# Access Compliance Report

## Public Rights-of-Way

| Intersection ID: 3423                   | Main Street: OVERLOOK_MOUNTAIN_DR | Cross Street: SOLEMN_POINTE_LN          | Location: NE           |
| ADA ID: C1D354263DD7                    | Ramp Type: Perp                   | Initial Pass/Fail: Fail                 | Overall Compliance: No |

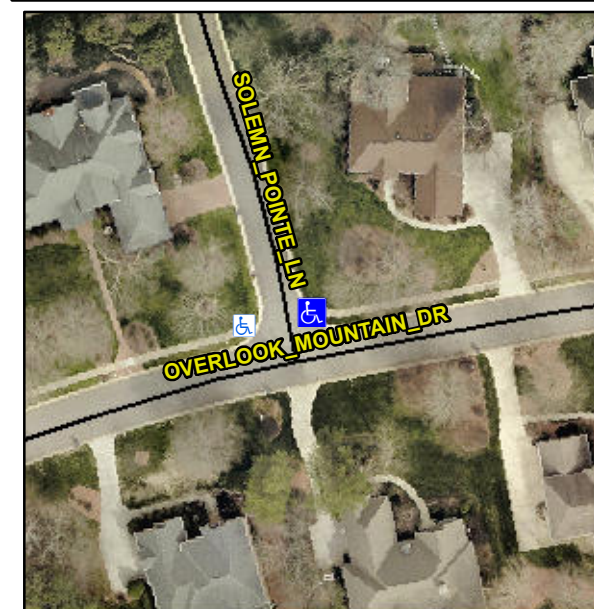
**Remove & Replace Entire Ramp.**

**R304.5.1**

| Compliance | Description           | Data | Compliance | Description                 | Data |
|------------|-----------------------|------|------------|-----------------------------|------|
| No         | Ramp Width (in)       | 44.5 | Yes        | Ramp XSlope (%)             | 1.8  |
